City of Richmond
Planning and Development Department

Re: **Application by – Matthew Cheng Architect Inc. for Development Permit at 8091 and 8131 No. 2 Road**

**Report to
Development Permit Panel**

Re: Application by Matthew Cheng Architect Inc. for a Development Permit at 8091
and 8131 No. 2 Road

LOT COVERAGE PLAN

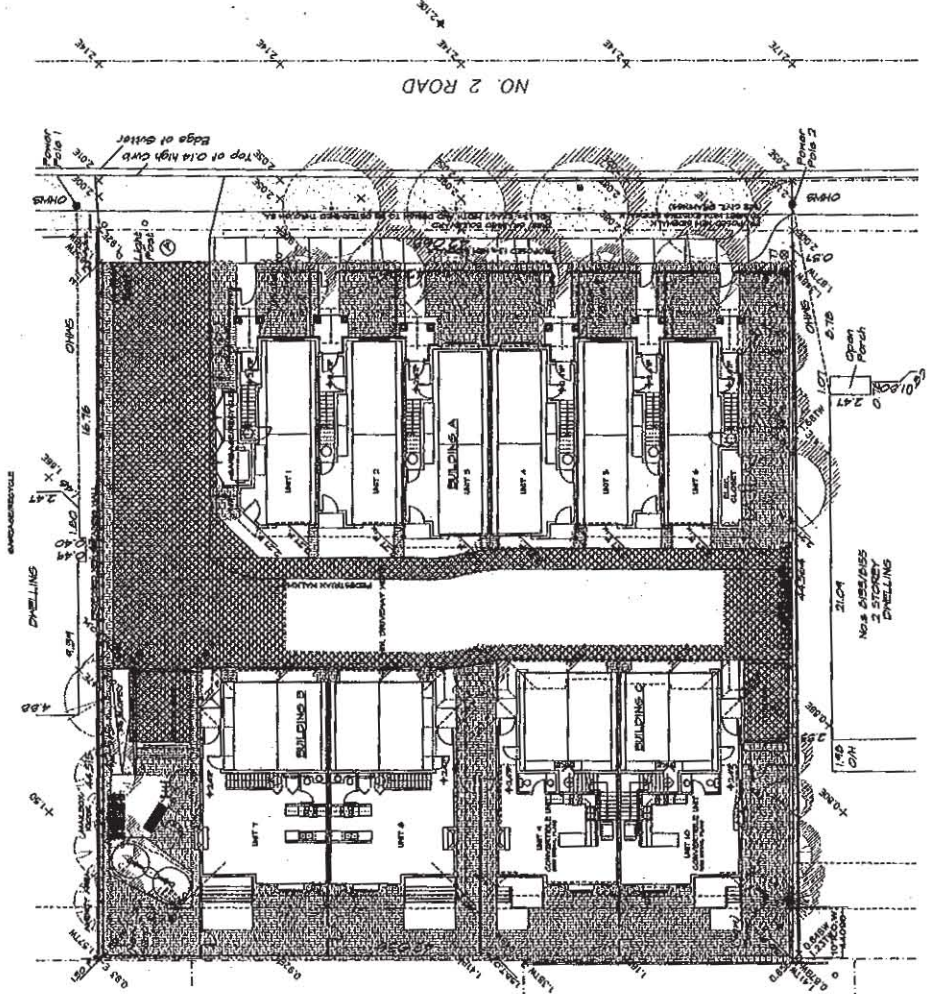
Variance – Live Plant Material

In addition to the increase in live plant material provided by the landscaped strip along the drive aisle, the applicant has proposed changes to incorporate additional soft landscaping within rear yards of Buildings B and C, and between garage aprons to increase the overall live plant material coverage from 22% to 25%. This results in a decrease to the extent of the requested variance. Staff are supportive of the revised variance request given the effort taken by the applicant to revise the proposed site plan which has resulted in a decrease to their overall floor area ratio from 0.66 to 0.65.

COVERAGE WITH LIVE PLANT MATERIALS
 4792.25 sq. ft. (4792.25 sq. ft.) 20.14%

COVERAGE WITH PERMIABLE SURFACE
 2865.86 sq. ft. (2865.86 sq. ft.) 18.00%

Sheet No: 09-494270-03
 BUILDING A
 ELEVATIONS

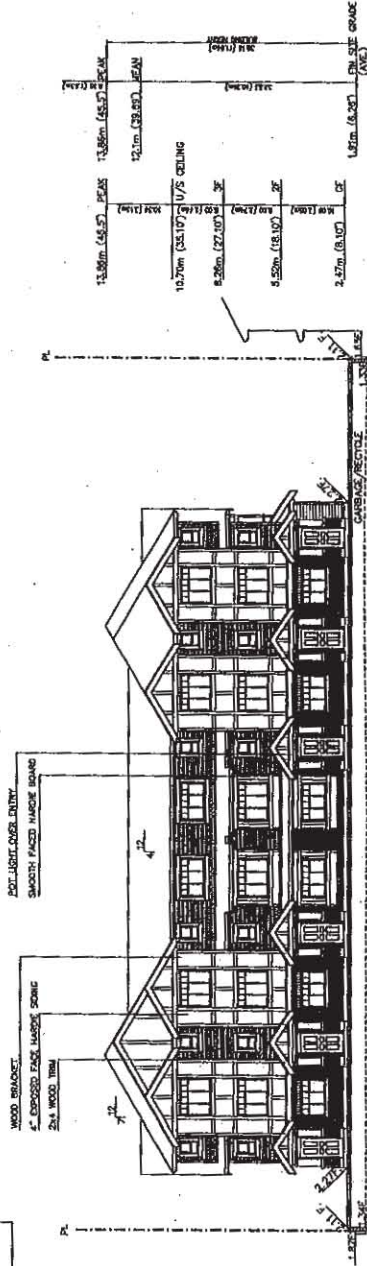
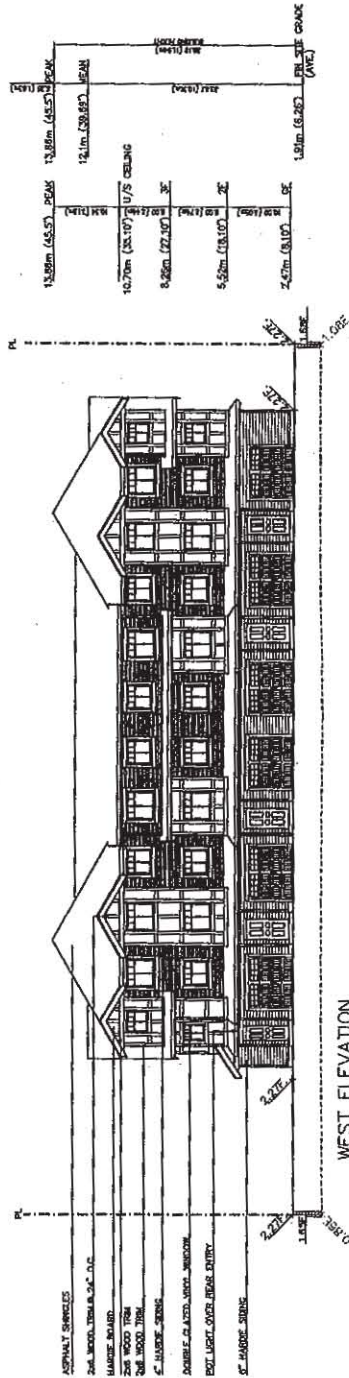
2. Design development to colour palette to increase richness and accent;
Along No. 2 Road, the colour palette has been revised to consist of red bricks with darker trims against the light hardie board and heritage bluish-grey hardie siding. Buildings B and C are with the same colour palette without the brick.
